Michael J Derivan comments/concerns on NuScale FSAR Chapter 15 Safety Analysis

I have been reviewing the NuScale FSAR Chapter 15 Safety Analysis (submitted for the Design Certification) for the 'Reduction in MFW Flow'. It is described in **FSAR 15.2.7.2**. I have some questions and concerns about this analysis in particular and in general how these NuScale Safety Analysis transient results will fit into the use of the NuScale Control Room Simulator used for the NuScale HFE program. The HFE program, in conjunction with the NuScale Simulator, is part of the NuScale plan to justify reduced Licensed Operator manning from what is required in NRC regulations. This is much discussed in other NuScale/NRC documents, and the HFE Program is described in other NuScale submittals.

Figure 15.0-9: Analytical Operating Limits

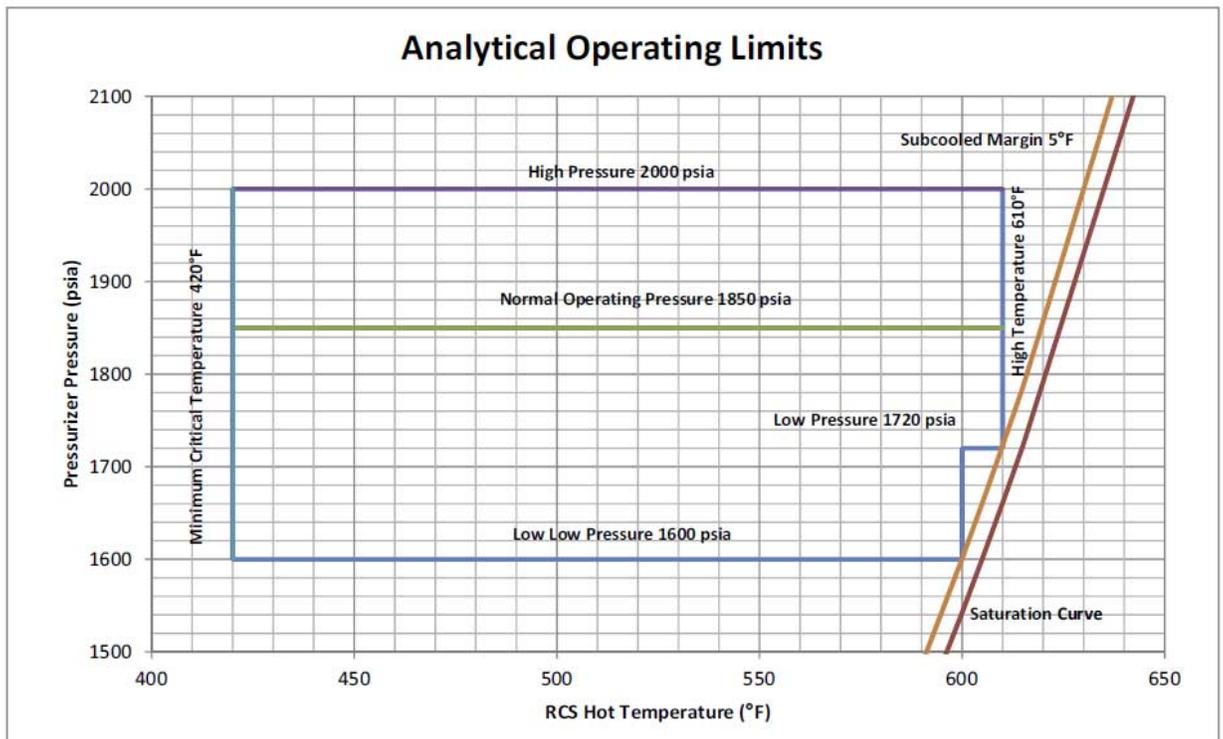
10. Has the NuScale Simulator OTSG (code) performance been benchmarked against the test runs of the OTSG done at the test facility in Italy?
11. FSAR Figure 15.0-9 has this P vs T graph:

A typical PWR (at least a B&W plant) has an SPDS display such as this where RCS P and T plot in real-time and maintain the 'history trace'. It is an extremely handy tool for Operators to monitor and diagnose plant up-sets.

- a) I'd like to see the NuScale FSAR 'Reduction in MFW Flow' SA transient results plotted on such a graph.
- b) Then also add (to the same graph) the same transient results run at the same Initial Conditions as the FSAR SA, for a run on the NuScale Simulator. (Provides a "sanity check" for the 2-codes/model comparison).
- c) Then I'd like to see the results for a Simulator run using all the same Input Values... except start with a T-ave using the negative bias value of 535F vice 555F. It would show if the NuScale SA transient IC is indeed "conservative."

Figure 5.1-2: Reactor Coolant System Simplified Diagram

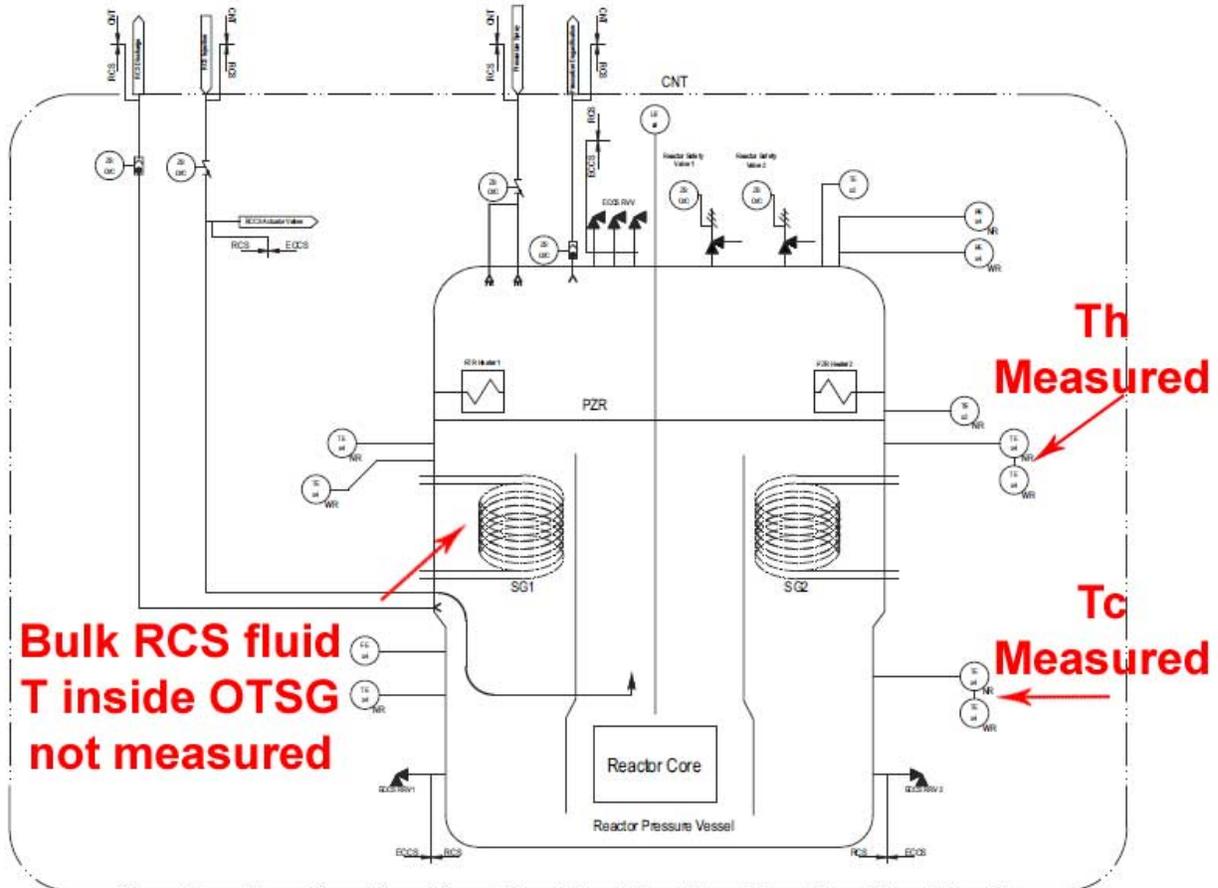
When the MFW Flow is reduced to an OTSG, and the Secondary Side water level starts to decrease (for NuScale OTSG, inside the tubes), the OTSG HT-X superheat region size starts to immediately increase in length. This means less heat is transferred **FROM** the bulk RCS fluid surrounding the OTSG tubes in that larger length HT-X region. Bottom line is the “cold side” T for natural circulation goes up. From just that affect, natural circulation flow rate has to go down. An extreme case example would be secondary side “dry out” from total Loss of MFW. In that case the RCS bulk fluid T around the OTSG tube bundle (inside the OTSG shell) would enter the OTSG shell at T_h and exit the shell bottom also at T_h since no heat would be removed inside the OTSG (the only OTSG HT-X region remaining would be a full-length superheat region.... I’ll acknowledge it can transfer some heat).

NOTE WELL this RCS T change happens inside the OTSG shell before that hotter RCS water ever moves outside the OTSG to the T_c measuring instruments. In a B&W PWR with OTSGs

this is why RCS P and Pressurize L start immediately increasing (and I mean IMMEDIATELY) even before the Tc instruments (or an Operator) can see it... and is why a B&W PWR is so sensitive to decreases in MFW Flow. The actual T-ave increases as fast as the OTSG water L decreases. But it can't be seen until the water reaches the measuring instruments. It is also why (with the "old" pre-TMI2 setpoints) on B&W plants a PORV would lift EVEN IF the Reactor Tripped simultaneous with a TLOMFW signal.

This is one reason I am curious about the RCS Loop Transport Time for the NuScale Unit.... hotter RCS water has to get all the way to the Th measurement to trip the Reactor on a 'reduction in MFW Flow'. The hotter water also has an effect on the ex-core NI reading as soon as it travels to the core region of the Pressure Vessel because neutron leakage will increase, depending on plant conditions when the NIs were calibrated to a calorimetric.

Figure 15.2-30: Reactor Coolant System Flowrate - Peak RCS Pressure Case (15.2.7 Loss of Feedwater)

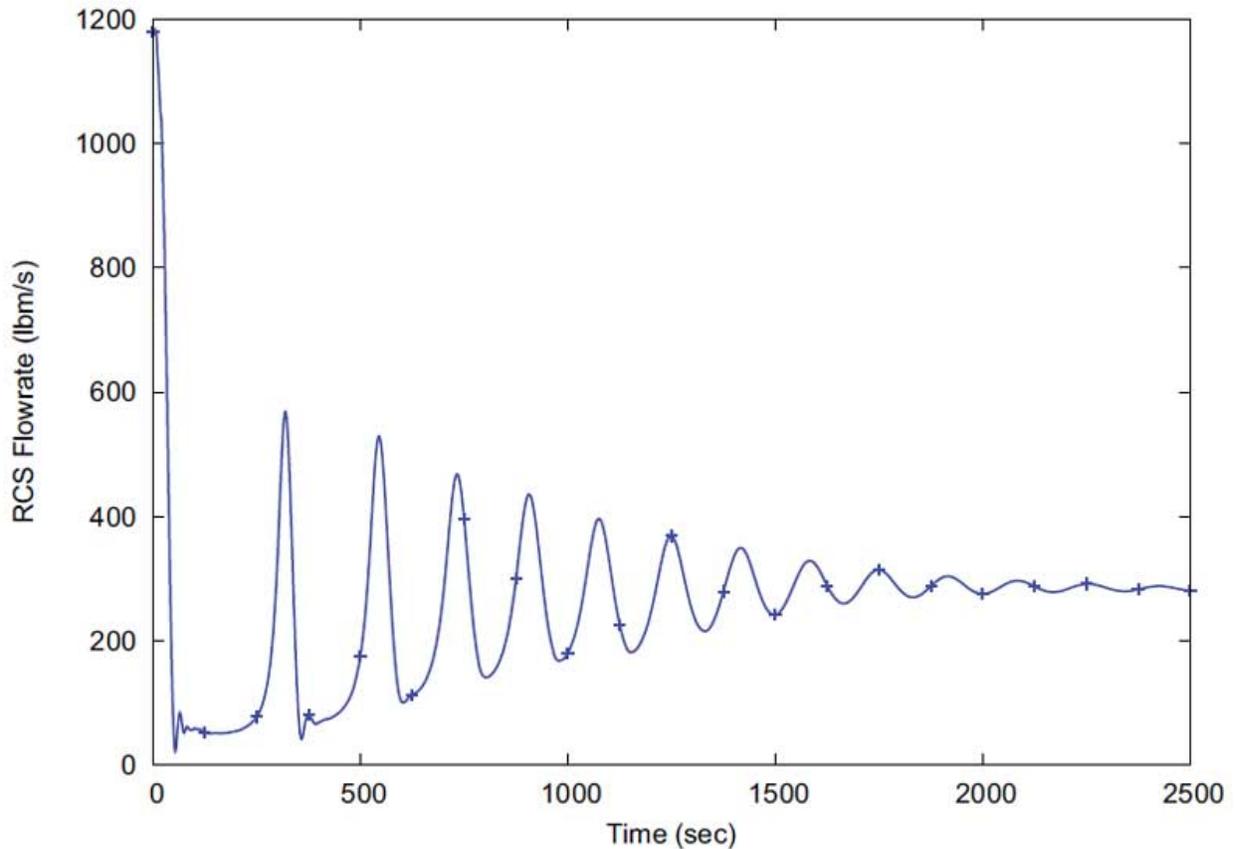
From **FSAR 15.2.7.3.3**:

“RCS flow (Figure 15.2-30) drops initially due to the reactor trip and stabilizes as DHRS flow is established.

This statement implies (and shows) RCS flow only decreases due to the Reactor Trip, 18 seconds after the event initiator (**FSAR Table 15.2-20**), not the loss of the natural circ driving head due the bulk fluid RCS T increase within the OTSG shell heat sink from the Secondary side dry-out after the 100% TLOMFV initiator. Eighteen seconds is more than enough time to change the Ts driving the delta-P for natural circ, and affecting natural circ flow well before the Reactor Trip. After all... some RCS Ts must be changing in these 18 seconds.... as the Pressurizer in-surges enough from RCS heat-up expansion to terminate the event on an HP trip!

I don't think THIS OPERATOR believes RCS natural circ flow doesn't change before the Reactor Trip, based on just the discussion in this FSAR Section. Either the event is not being thoroughly explained in the text, or the NRELAP code is bogus.

In my wildest imagination I might conjure up an explanation claiming that as RCS bulk T inside the OTSG shell increases due to loss of Secondary heat sink, and as natural circ flow “tries” to decrease, it causes Reactor core flow to decrease causing a corresponding increase on the “hot side” T... and then “a miracle occurs” and magically the delta-P driving force for natural circ stays constant so the flow stays constant. If true an Operator needs to know that.
